DOCUMENT 00912

**ADDENDUM NUMBER 2**

Issued: February 15, 2011

**Russian River County Sanitation District Treatment Plant Disinfection Upgrade Project**

**DISINFECTION UPGRADE PROJECT  
STANDARD STRUCTURAL NOTES**

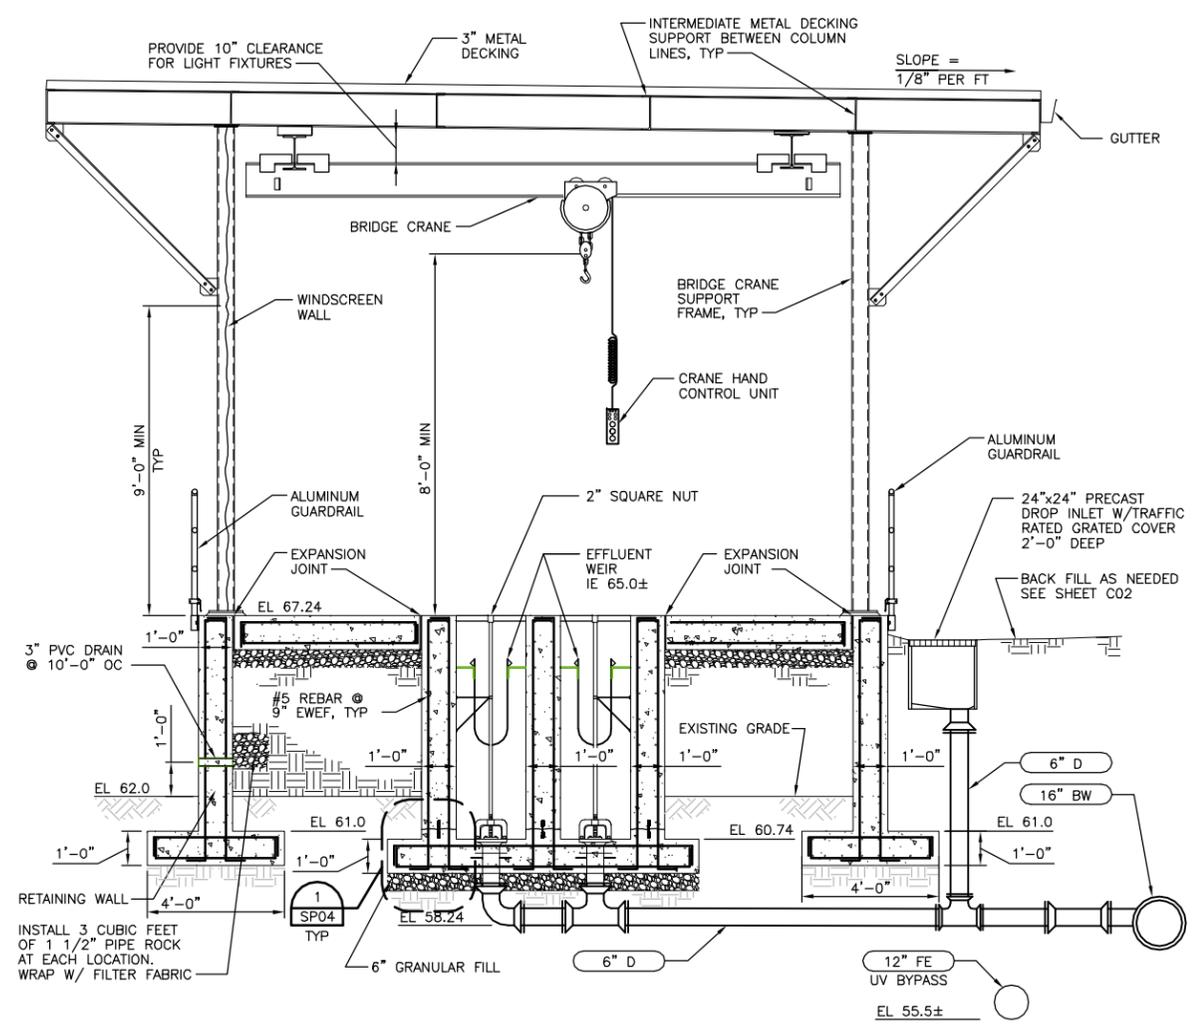
- A. Delete Drawing SP01 and replace with attached Drawing SP01, marked "2/15 ADDENDUM No. 2."
- B. Drawing SP05:
  - 1. Change "#5 REBAR @ 9" EW/EF (TYP)" in two locations to read:  
"#5 REBAR @ 6" EW/EF (TYP)"
- C. Drawing SP06:
  - 1. Detail Markers in Sections A, B, and C: change Detail Number from "9" to "1."
- D. Delete Drawing SP07 and replace with attached Drawing SP07, marked "2/15 ADDENDUM No. 2."
- E. Delete Drawing SP08 and replace with attached Drawing SP08, marked "2/15 ADDENDUM No. 2."
- F. Delete Drawing SP09 and replace with attached Drawing SP09, marked "2/15 ADDENDUM No. 2."
